**PUBLIC INQUIRY TO CONSIDER SECTION 36 ELECTRICITY ACT 1989  
APPLICATIONS BY:**

- (1) STEADINGS WINDFARM LIMITED FOR CONSENT AND DEEMED PLANNING PERMISSION TO CONSTRUCT AND OPERATE A WINDFARM AT KIRKWHELPINGTON, NORTHUMBERLAND (KNOWN AS STEADINGS)**
- (2) AMEC PROJECT INVESTMENTS LIMITED FOR CONSENT AND DEEMED PLANNING PERMISSION TO CONSTRUCT AND OPERATE A WINDFARM AT RAY ESTATE, NORTHUMBERLAND (KNOWN AS RAY WINDFARM)**
- (3) WIND PROSPECTS DEVELOPMENT LIMITED FOR CONSENT AND DEEMED PLANNING PERMISSION TO CONSTRUCT AND OPERATE A WINDFARM AT GREEN RIGG FELL, BIRTLEY, NORTHUMBERLAND (KNOWN AS GREEN RIGG WINDFARM)**

**MARK SPENCER  
REBUTTAL PROOF OF EVIDENCE  
IN SUPPORT OF OBJECTION BY  
MINISTRY OF DEFENCE**

**Figure 1** – Lowther Hill predicted radar coverage for a hawk target flying at an altitude of 2500ft above ground level  
Scale: Radar Range rings at 10nm intervals

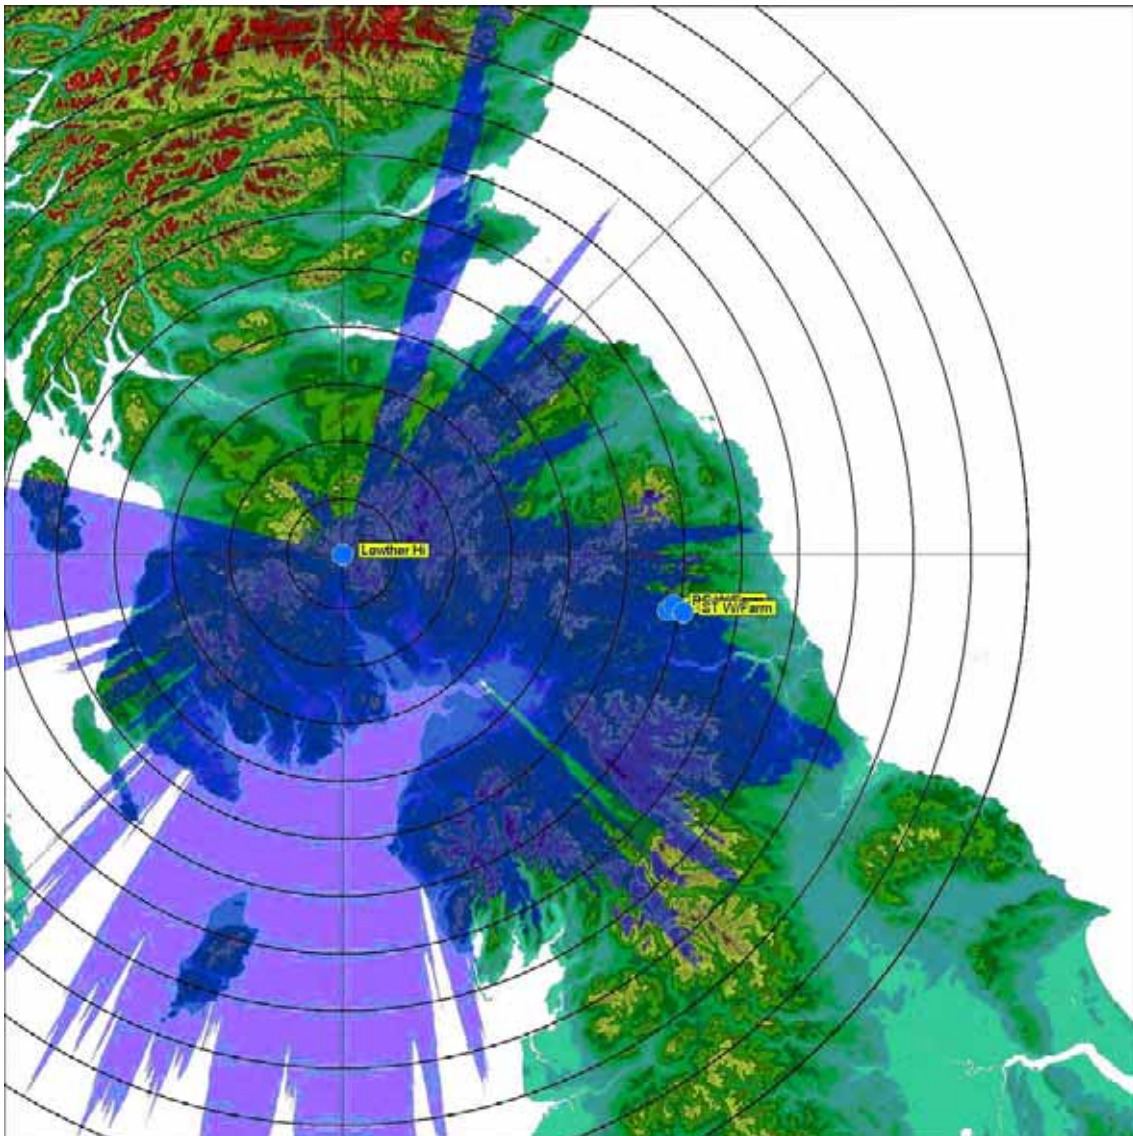
56. Also, the Lowther Hill radar does not have sufficient radar coverage of the area of the proposed wind farms at the requisite flight levels for the mitigation to work. Unfortunately, it suffers from the opposite problem to the Spadeadam radars in the tilting mitigation – at 3000ft agl the terrain shields too much of the area from the radar. In order for the composite picture to be reliable enough to be used for ATC, the patching radar has to be able to see for 10 nm around the wind farms. This is so that an aircraft can maintain separation of 5nm from the wind farms and be sure that it is also 5nm away from any other traffic or hazards near the wind

farms. Lowther Hill does not have a clear 10 nm view around the proposed wind farms.

57. Figure 1 shows Lowther Hill radar predicted coverage for a Hawk aircraft flying at an altitude of 2500ft above ground level, the blue shaded areas represent the areas in which the aircraft would be seen, it is important to note the coverage north and north east of the proposed windfarms is intermittent at best.
